Access Compliance Report

Public Rights-of-Way

(Curb Ramps)

Intersection ID: 3954	Main Street: MOUNTAIN_COVE_DR	Cross Street: OVERLOOK_COVE_RD	Location: NW
ADA ID: B1C0E693A591	Ramp Type: Perp	Initial Pass/Fail: Fail	Overall Compliance: No
Severity Score: 33.75			
Codes/Mitigation Info/Possible Solution		Field Measurements/Component Compliance

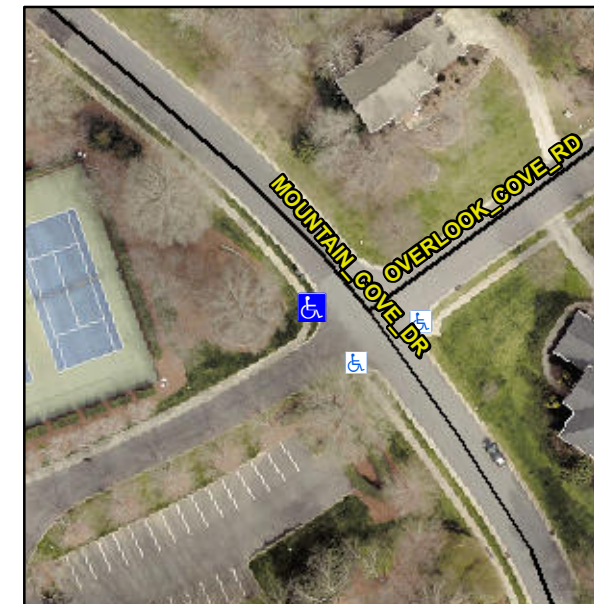
Not Found, R304.5.1, R304.5.3

Compliance	Description	Data	Compliance	Description	Data
N/A	Ramp Length (in)	47.0	Yes	Ramp Slope (%)	7.2
No	Ramp Width (in)	46.5	No	Ramp XSlope (%)	13.4
N/A	Flare Type LT	N/A	N/A	Flare Type RT	N/A
N/A	Flare Slope LT (%)	N/A	N/A	Flare Slope RT (%)	N/A
N/A	Flare Traversable LT?	N/A	N/A	Flare Traversable RT?	N/A
N/A	Landing Length (in)	N/A	N/A	DWS Provided?	N/A
N/A	Landing Width (in)	N/A	N/A	DWS Contrast?	N/A
N/A	Landing Slope (%)	N/A	N/A	DWS Length (in)	N/A
N/A	Landing X Slope (%)	N/A	N/A	DWS Full Width?	N/A
N/A	Landing Curb? (Y/N)	N/A	N/A	DWS Offset (in)	N/A
N/A	Shared Landing?	N/A			
N/A	Gutter Ponding?	N/A	N/A	Gutter Slope (%)	N/A
N/A	Gutter Lip Ht (in)	N/A	N/A	Gutter X Slope (%)	N/A
N/A	Painted X Walk1?	No	N/A	Painted X Walk2?	N/A
	X Walk 1 Direction	To SE		X Walk 2 Direction	N/A
N/A	X Walk 1 Width (in)	N/A	N/A	X Walk 2 Width (in)	N/A
	X Walk 1 Slope (%)	3.6		X Walk 2 Slope (%)	N/A
	X Walk 1 X Slope (%)	6.5		X Walk 2 X Slope (%)	N/A

Remove & Replace Entire Ramp.
